Manual 07 Update – Revision 5

PJM Protection Standards

Stan Sliwa, P.E.
Transmission Planning
Markets & Reliability Committee
September 25, 2025

Figure 1. Acceptable Configuration

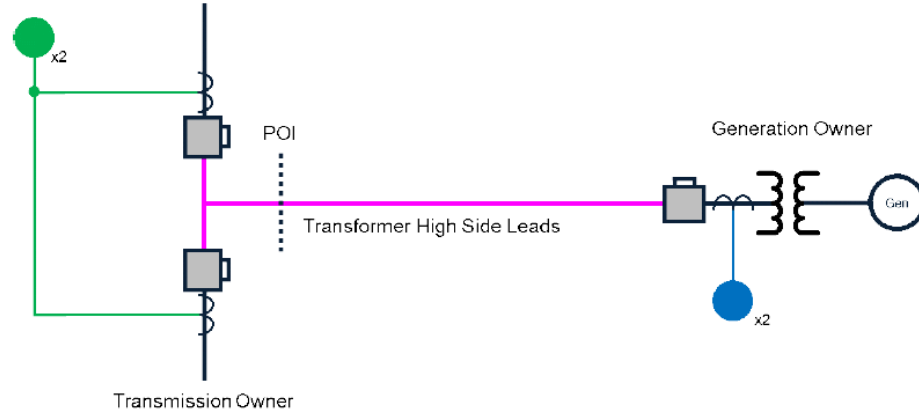
- Enhanced section 4.2 on transformer high-side lead protection with more details and added reference diagrams

In Section 4.2.1 several examples of acceptable configurations are provided; this is not an exhaustive list. Other configurations of both the protection and phase conductor are possible while satisfying the requirements. Additionally, Section 4.2.1 provides a possible system configuration that is prohibited.

The transformer high-side leads are required to be protected by two independent current differential schemes ~~or equivalent high-speed schemes~~. The schemes must utilize independent current sources and independently protected DC control circuits.

Transformer high-side leads shall not have infeed within the protection zone as experienced by the two independent current differential schemes. Transformer high-side leads shall not have more than two terminals as experienced by the two independent current differential schemes.
